December 31, 1982
ST-HL-AE-919
File No: G9.15

South Texas Project
Units 1 & 2
Docket Nos. STN 50-498, STN 50-499
Responses to NRC Review Questions

RESPONSES TO NRC QUESTIONS
220.06, 220.08, 220.09,
230.01, 230.04, 231.02 and 231.03

Figure 1

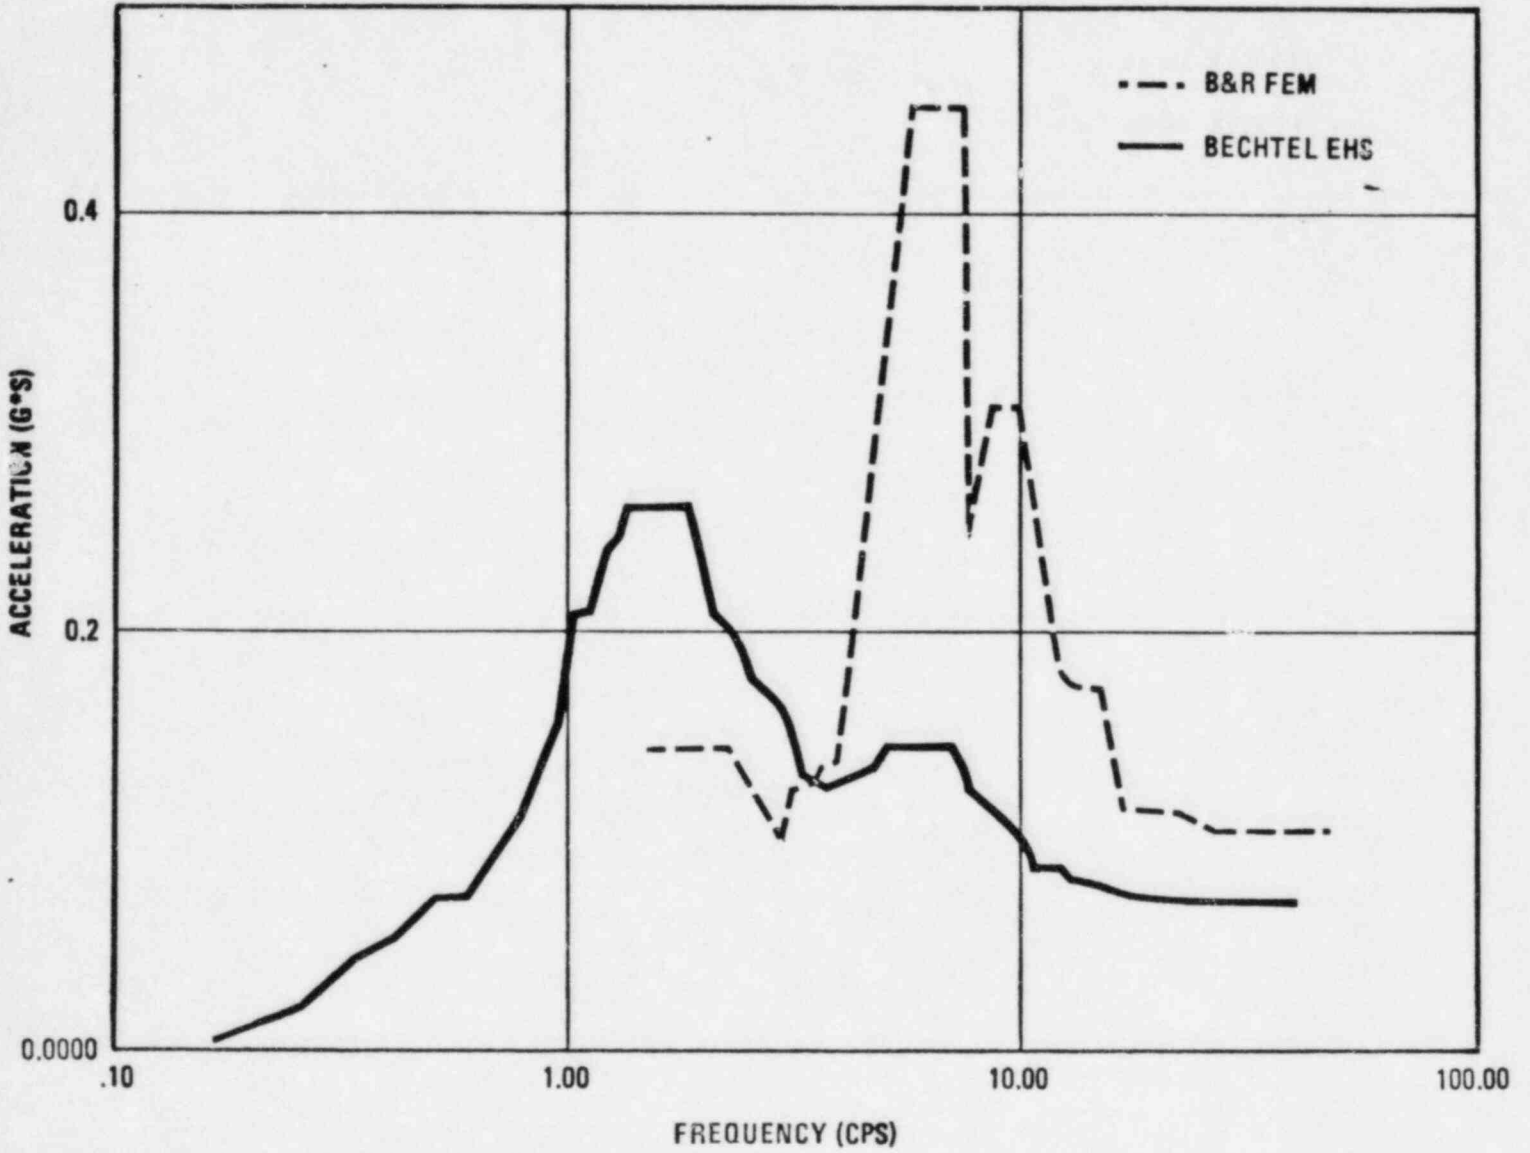
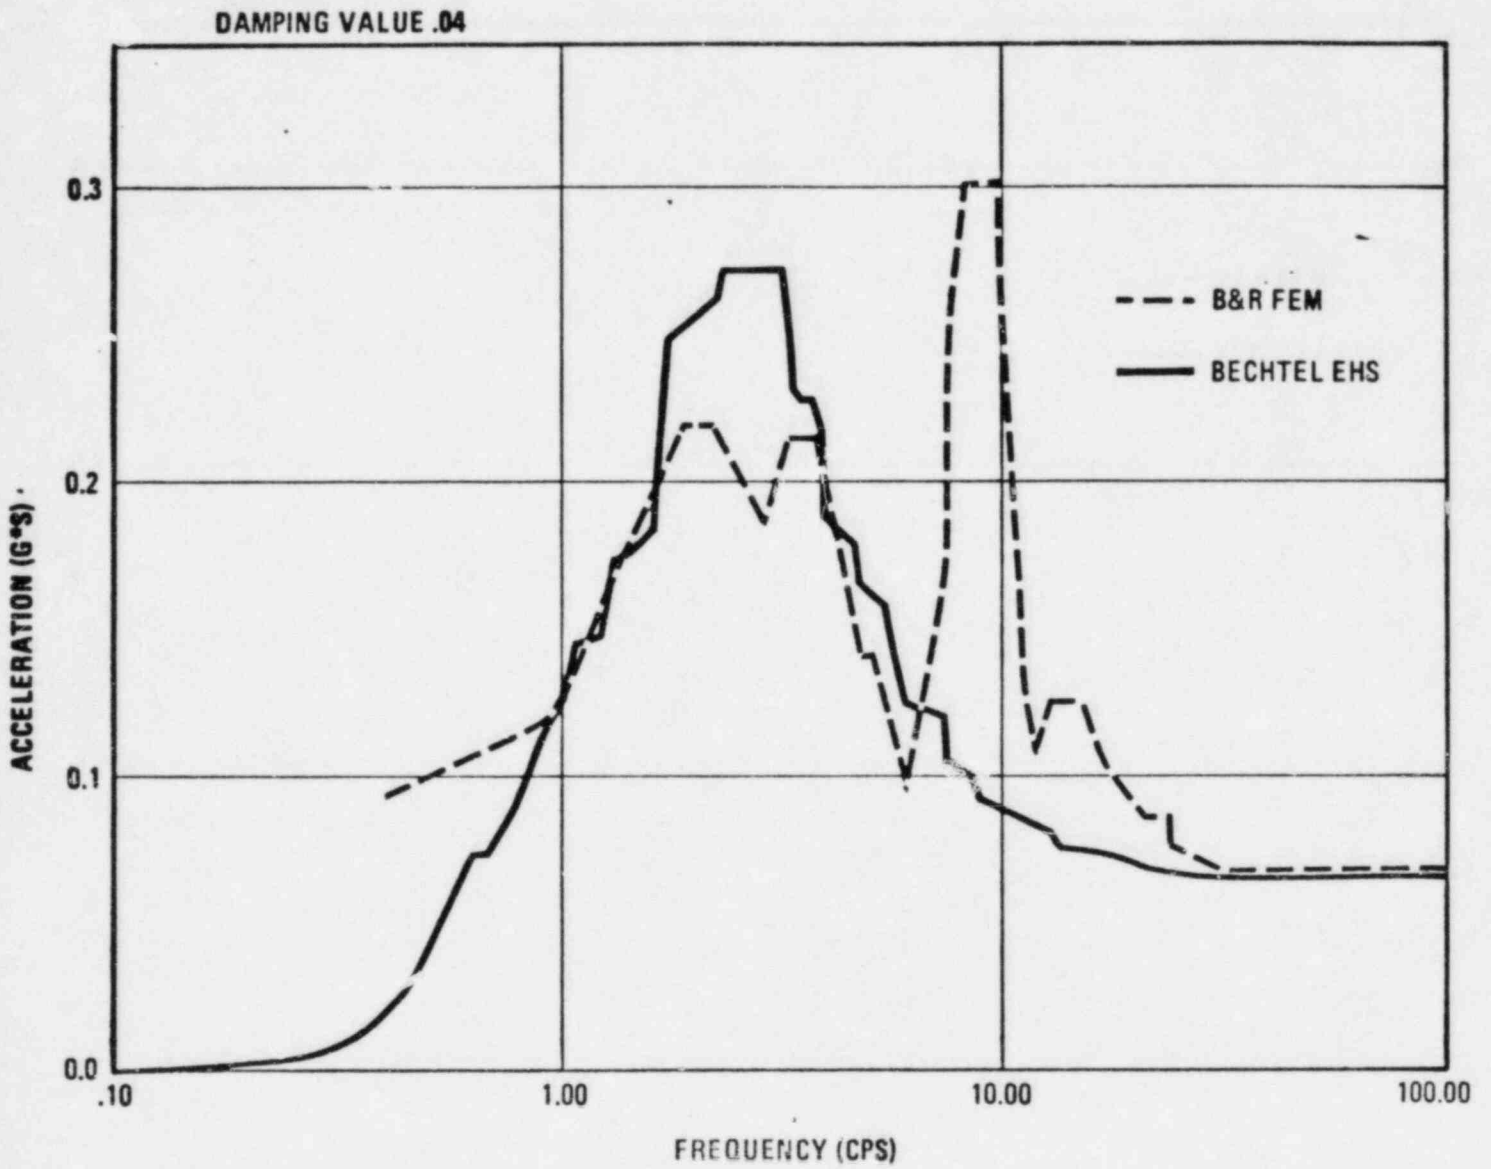
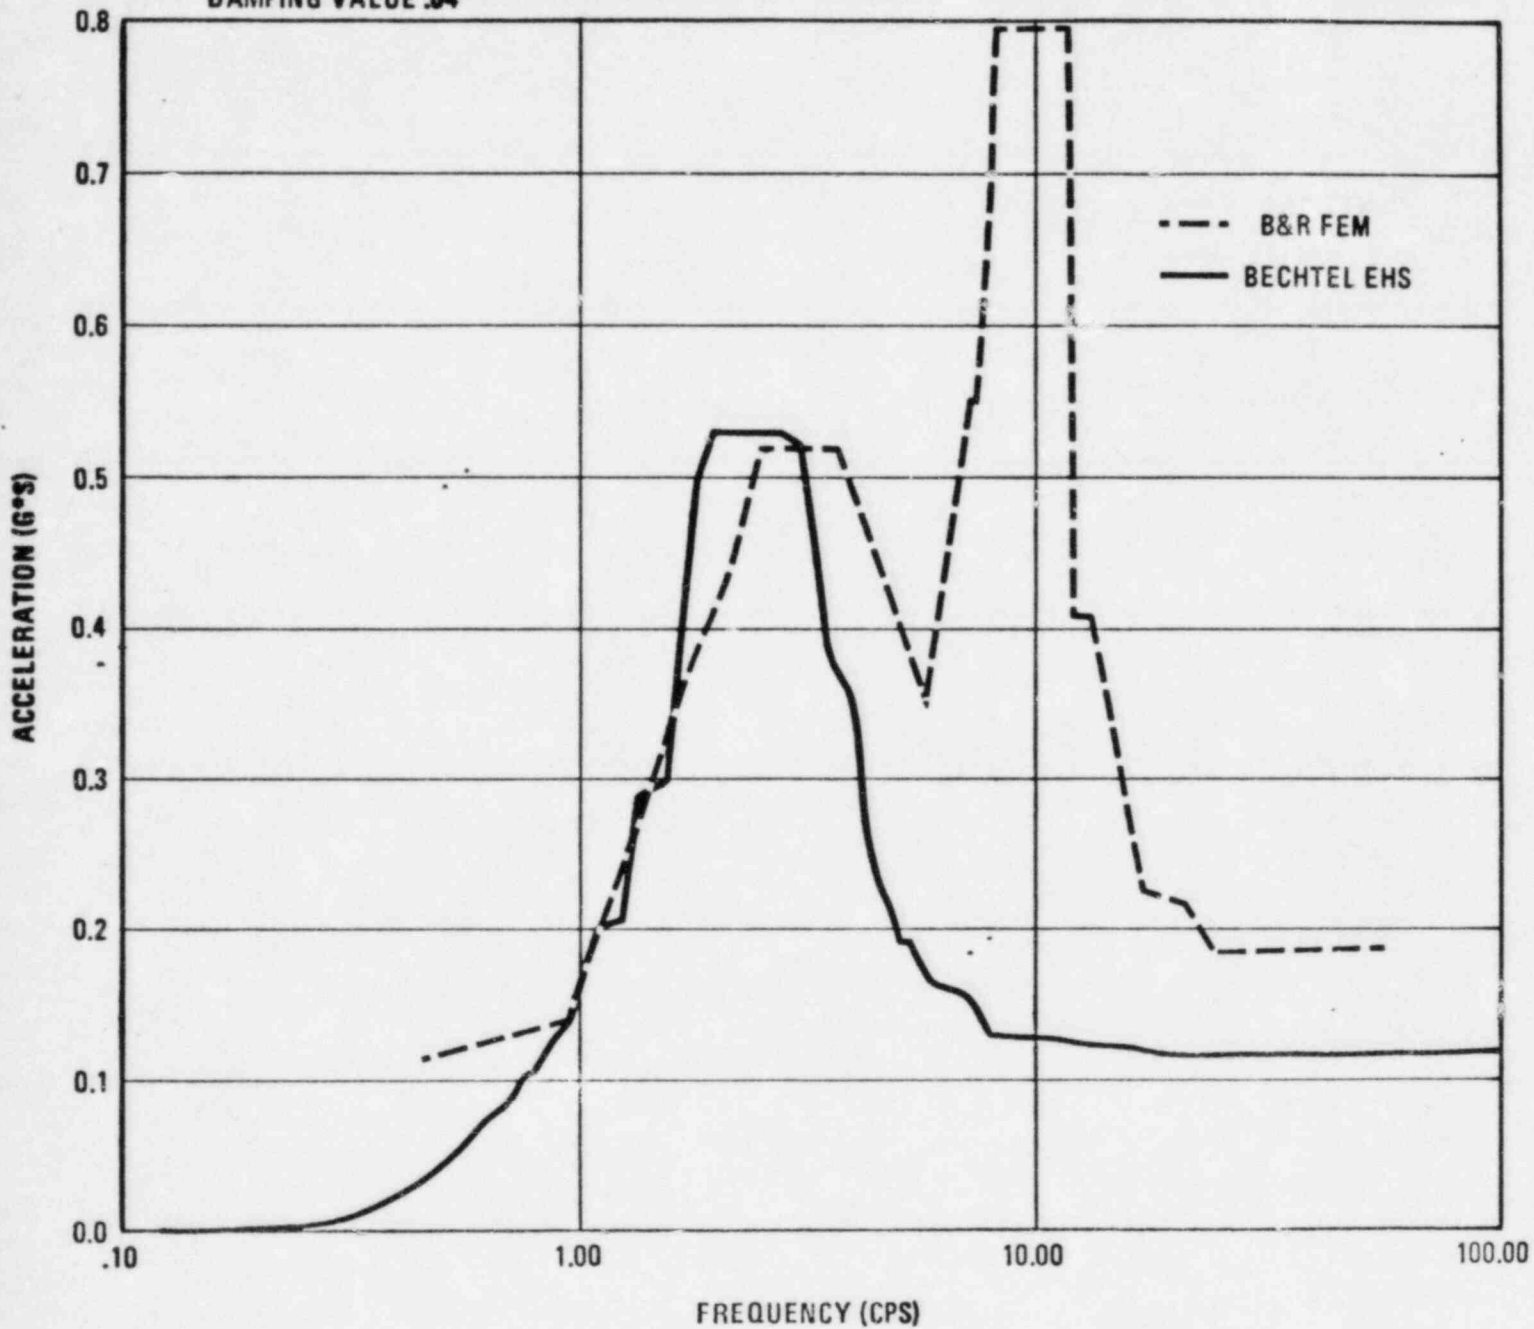
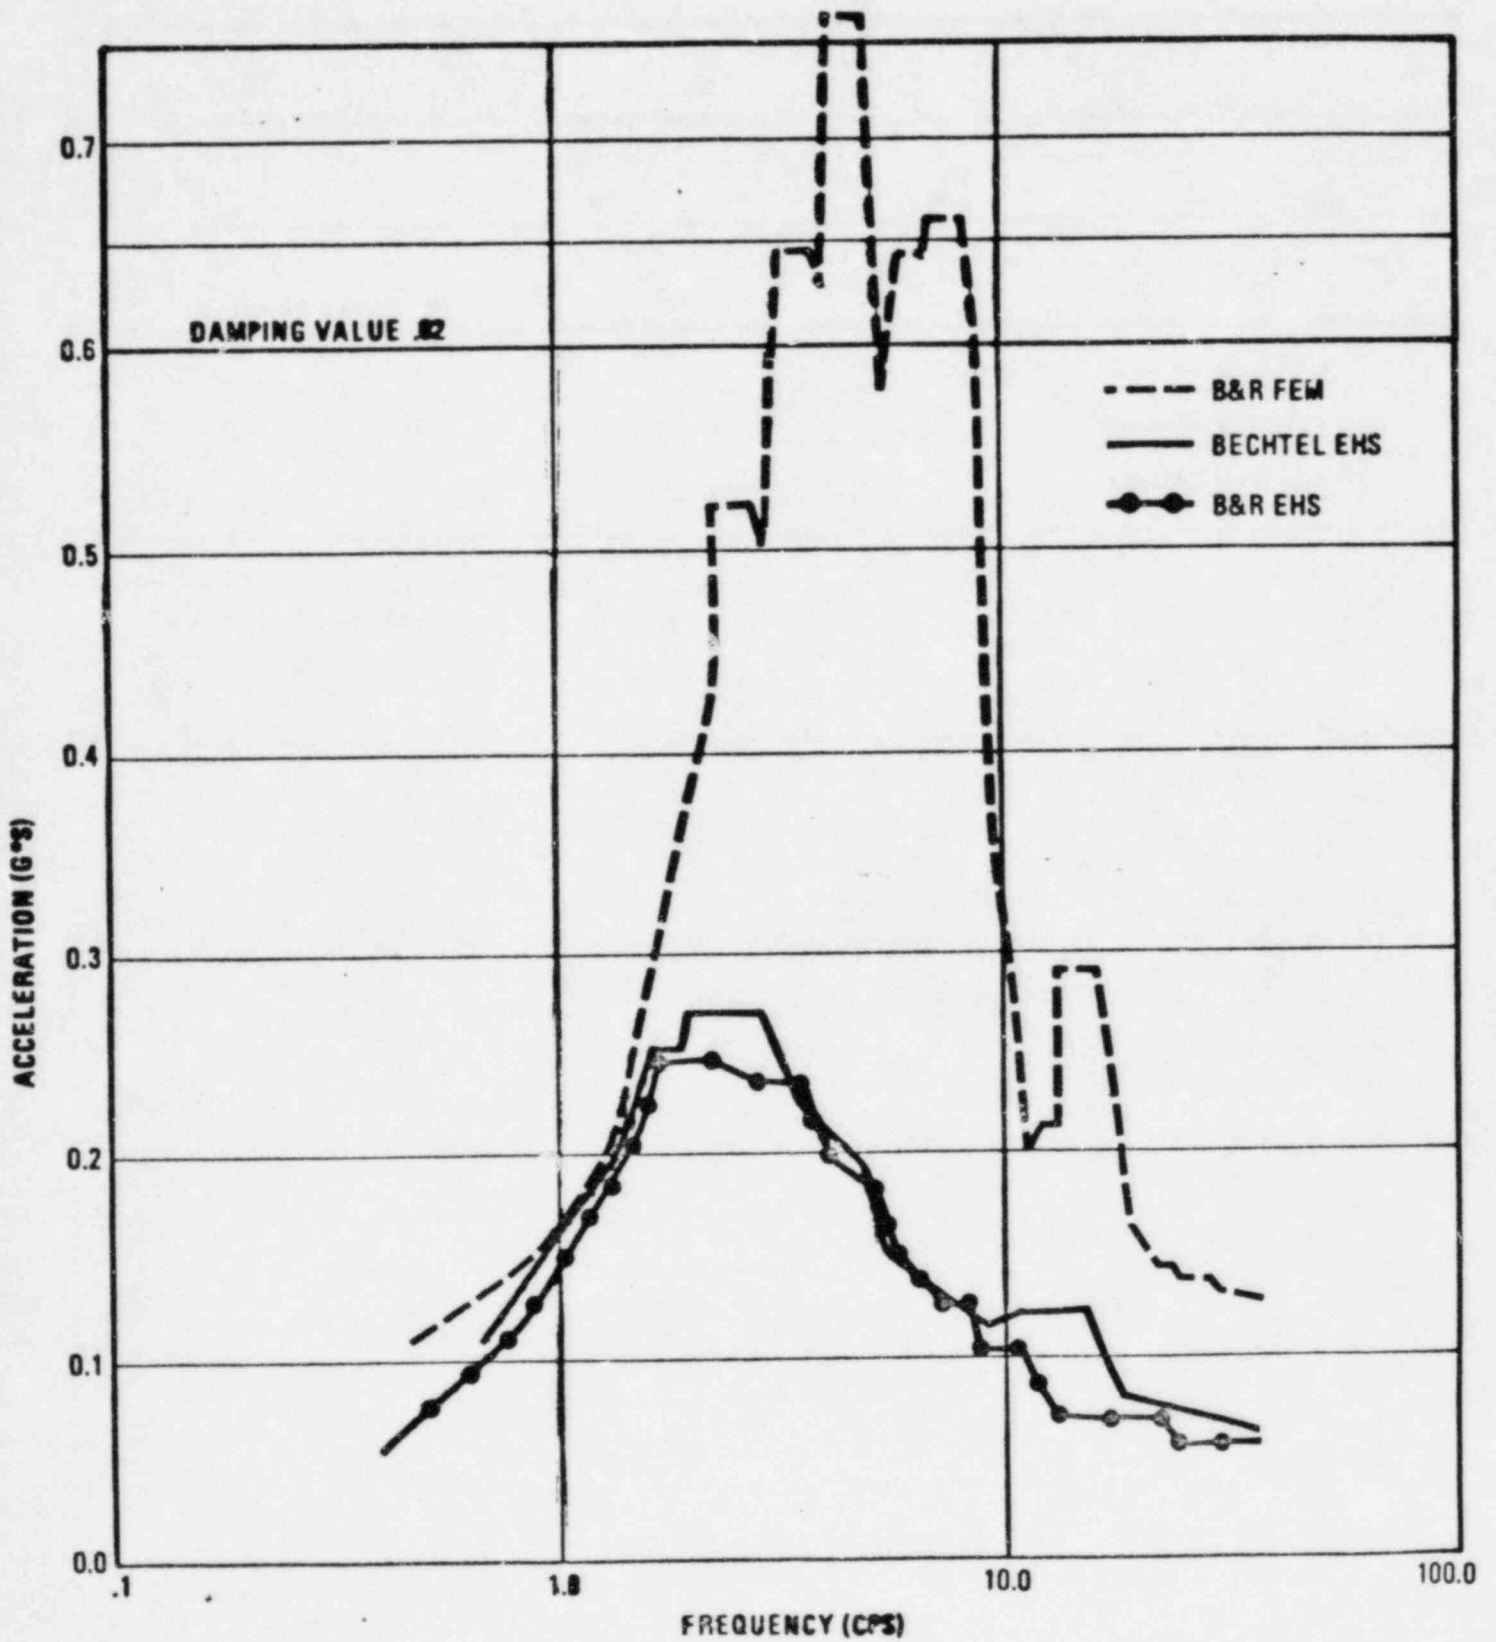
Use Elastic Half Space Method of Analysis without reducing the input motion due to embedment of structure in soil. Apply the R.G. 1.60 motion properly anchored at the OBE/SSE "g" values in the free field at the foundation level, and compare the resulting response spectra with those of Finite Element Method. The applicant should demonstrate that at least the intent of the following position is fully met:

The above mentioned comparison of floor response spectra needs to be done only for key structures at key levels, e.g., 6 key levels of reactor containment building, 4 key levels of auxiliary building, etc.

The FEM spectra envelopes the EHS spectra for the frequency range that is relevant for the design and/or qualification of structural elements, and essentially all equipment and components. The most significant difference is restricted to the low frequency range ($f < 4$ cps, generally), corresponding to soil-structure interaction frequencies where the EHS spectral response for horizontal directions in some buildings is distinctly higher than the FEM spectra. This difference prevails and is significant only in the RCB. In the FHB and the DGB the difference is evident to an insignificant extent, and in the MEAB it is essentially non-existent (see figures 1, 2, 3 and 4). Therefore the difference is well bounded and suitable for systematic assessment by natural-frequency segregation of the limited number of items susceptible to the higher seismic response developed exclusively in the low frequency range.

The comparison of FEM and EHS response spectra has been performed for the RCB, MEAB, FHB and DGB for the OBE event. All levels and locations within buildings corresponding to the original spectra will be compared for OBE and SSE events in order to permit complete implementation of the program described above.

The EHS spectra does not result in higher zero-period accelerations nor in higher peak amplifications than those obtained from the FEM spectra. Therefore the seismic designs of all the superstructures and most of the structural subsystems, which invariably have frequencies higher than 4 cps or are already designed for near peak seismic response, are not affected by the EHS-augmented spectra. Accordingly there is no need to rely on a justification of structures by means of existing design margins nor by means of the actual as-built material strengths as suggested in Question 220.08.
